Report to the Future Melbourne Committee

Agenda item 6.1

Planning Permit Application: TP-2020-357

5 Curran Street, North Melbourne

Figure 8. Encroachment of upper floor into required setback of B17 (Source: MGS Architects)

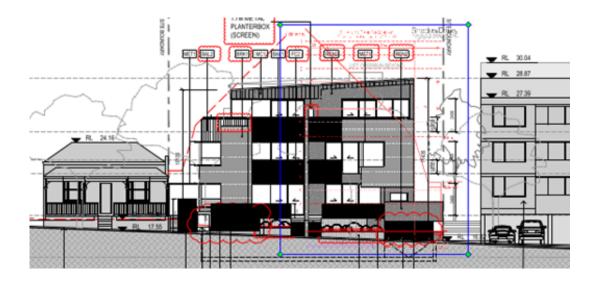
As per the attached Clause 55 Assessment, the side and rear setbacks comply with the requirements of Standard B17, aside from those proposed for the upper level on the west side of the building. The third level of the building will encroach into the recommended side setback of Standard B17, as shown below.

Despite this, it is considered that the objective - to ensure that the height and setback of the building from the shared boundary limits the impact on the amenity of existing dwellings - has been met. The adjoining building does feature some habitable room windows which face the subject site, although it is noted the ground level of the building features under croft parking only. The applicant submits that, if this was taken into account and the setback profile applied from the first floor (where there are habitable room windows), the development would comply with the requirements of Standard B17.
